Groundwater Transfer Review Summary Form

Transfer/PA # T- 12876

Application: T-12876

Applicant Name: Horta Latitude 45, LLC c/o George Xidias

Figure 1: Theis drawdown at 2 different distances from the pumping well, representing the distance from CLAC 13214 to the Authorized POA (left) and to Proposed Well 2 (right).

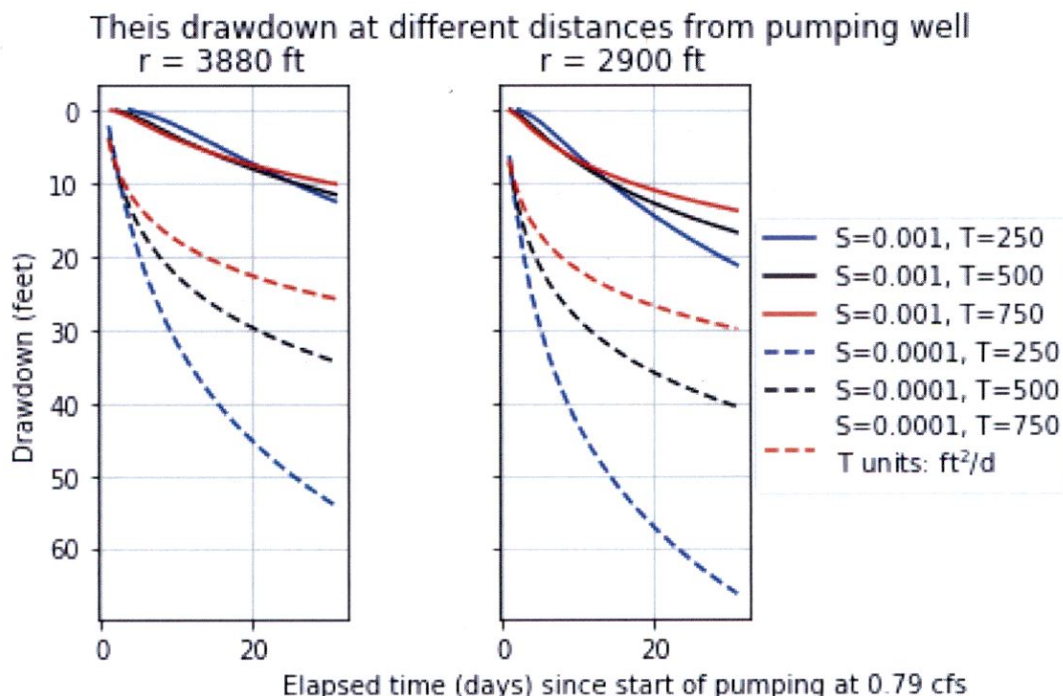
The increase in interference in CLAC 13214 by pumping Proposed Well 2 (distance 2900') compared with the Authorized Well (distance 3380') was estimated using the Theis equation. Using aquifer parameters derived from pump tests in the Authorized Well and nearby wells and assuming constant pumping at the maximum rate (355 gpm) until the maximum annual volume (47.8 AF, from 5.0 AF/acre on 9.56 acres) is reached (after 31 days), the estimated increase in interference at CLAC 13214 was limited to approximately 12 feet (Figure 1 and Figure 2 below). Given the 362' depth of CLAC 13214 and reported static water level of 25' below land surfaces on 4/20/1988, it is unlikely that this amount of increased interference will prevent the well owners from receiving the water to which they are legally entitled.

Figure 3: Water level data from wells with in approximately 1 mile of the applicant's wells.

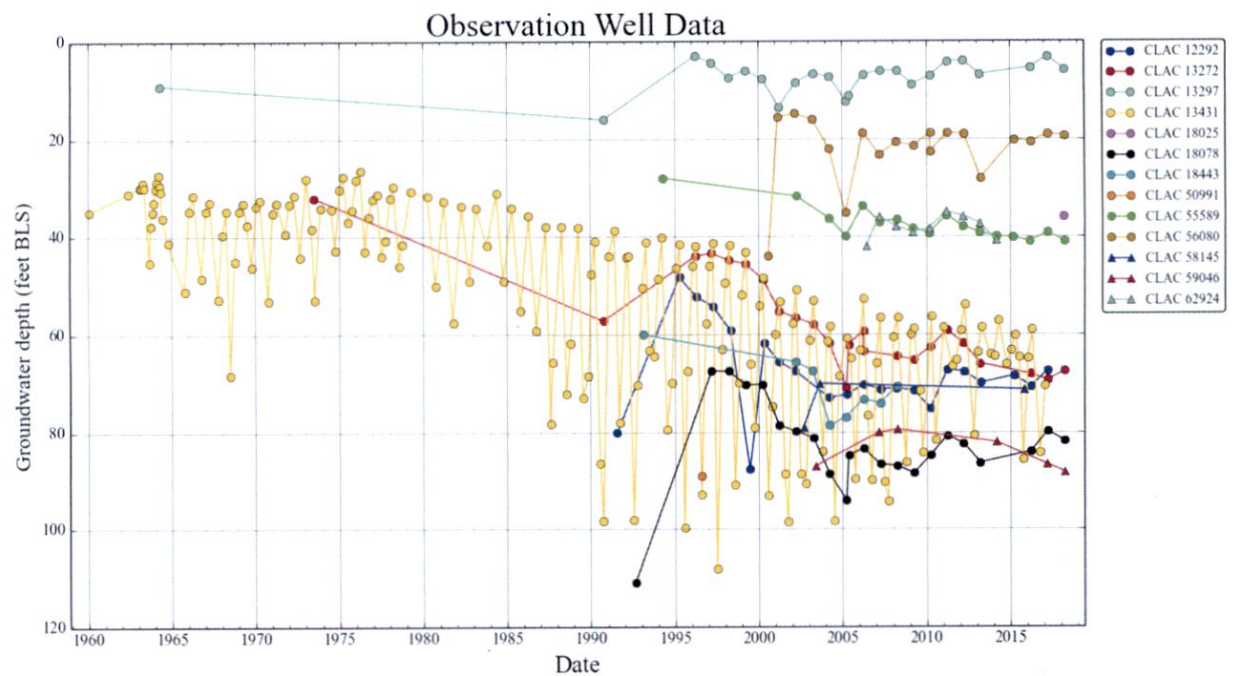
Similarly, wells that are nearer than CLAC 13214 and located such that the proposed transfer might lead to increased interference all have water levels more than 60' above the bottom of the well. While wells in the general vicinity have shown seasonal swings in water levels of nearly 60' in the past (see CLAC 13431, located roughly 2 miles SW of the applicant's wells, in Figure 3), recent seasonal variation appears to be closer to 30'. An analysis considering these factors, along with expected drawdown during normal use, indicates that even 12' of extra interference from the proposed transfer should not cause water levels to reach the bottom of these wells.

Figure 4: Map of applicant's wells and the surrounding region.

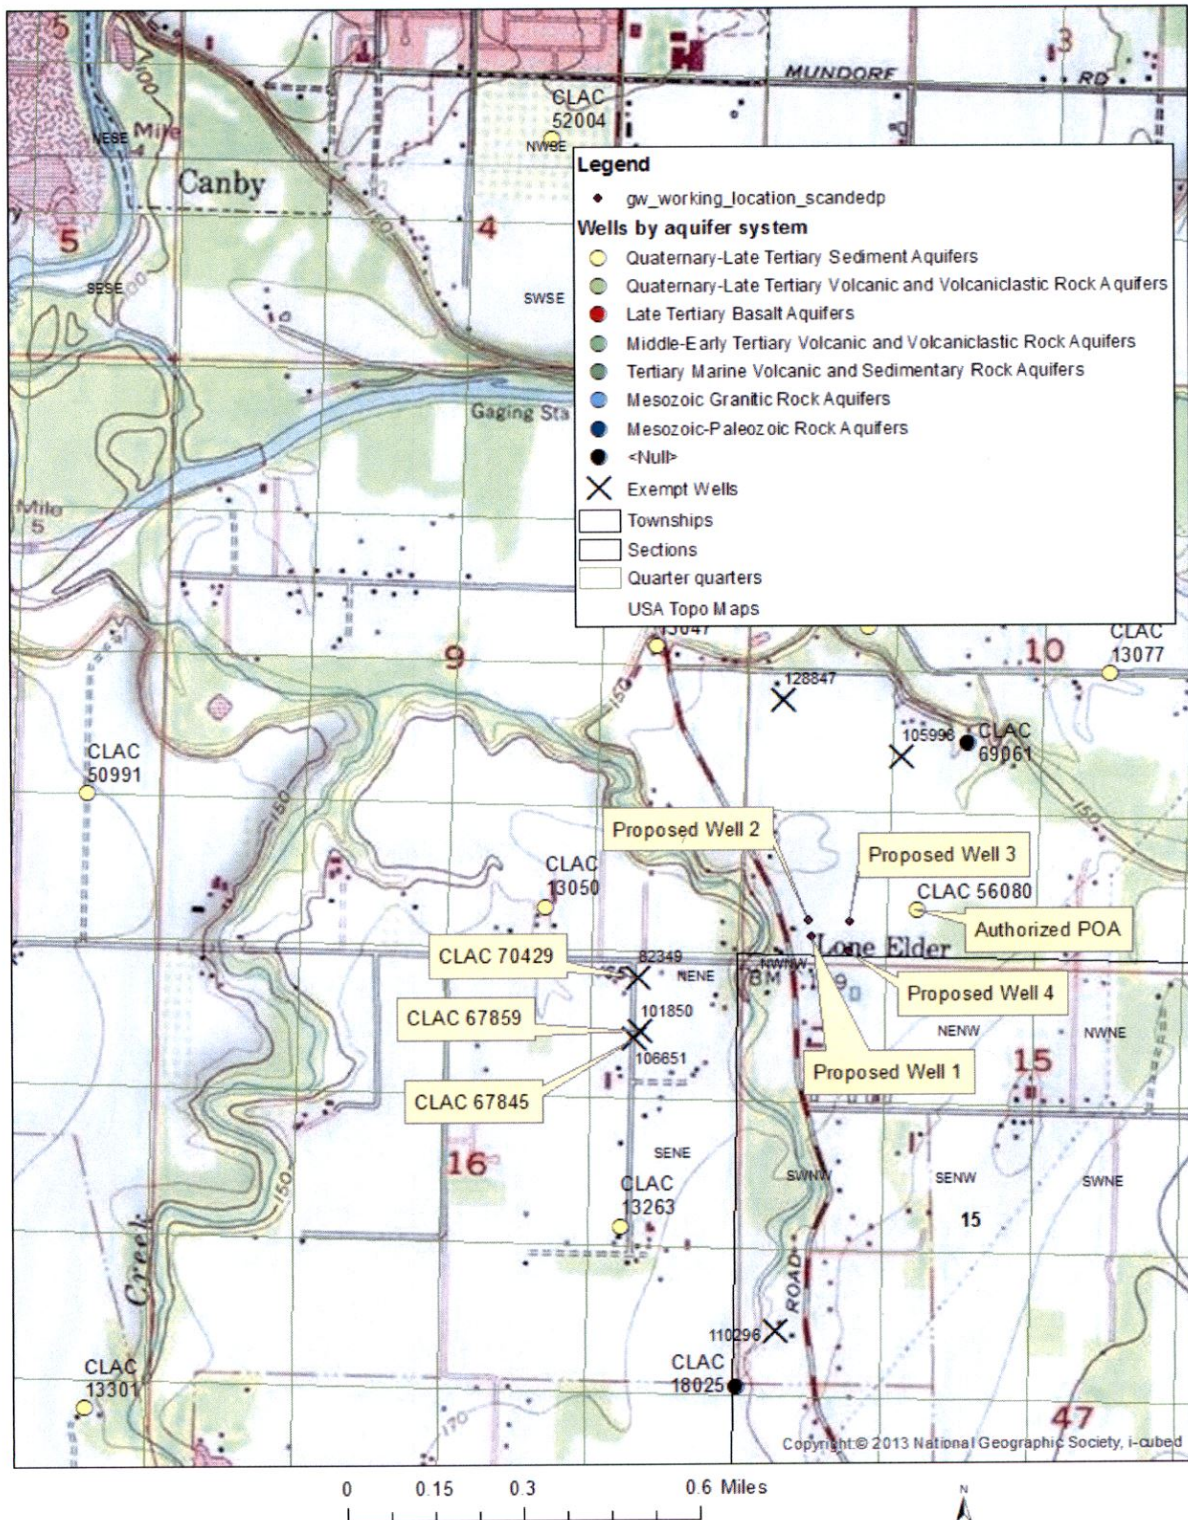
☒ Yes ☐ No Comments: Under this transfer, a new POA could move as much as 980' from the authorized POA location, bringing it closer to other nearby groundwater rights. The maximum increase in interference would occur if 355 gpm was transferred from the Authorized POA to Proposed Well 1 or Proposed Well 2, the farthest proposed well locations. Such a transfer would increase interference with a number of nearby wells to the west that are completed in shallower portions of the alluvial aquifer system, including at least 3 exempt domestic wells, CLAC 13050 on Claim GR-2242, and CLAC 13263 on Certificate 34113. It would also impact wells CLAC 13214 and CLAC 50991, which are similarly completed to the applicant's wells.

☒ Yes ☐ No Comments: Moving the POA from the Authorized Well to the Proposed Well 2 location would decrease the horizontal distance to Dove Creek (SW #1) from 1400' to 430'.

5. What conditions or other changes in the application are necessary to address any potential issues identified above: The proposed wells should be sealed to a depth of at least 200' to limit potential interference with nearby, shallow domestic wells.
6. Any additional comments: _____
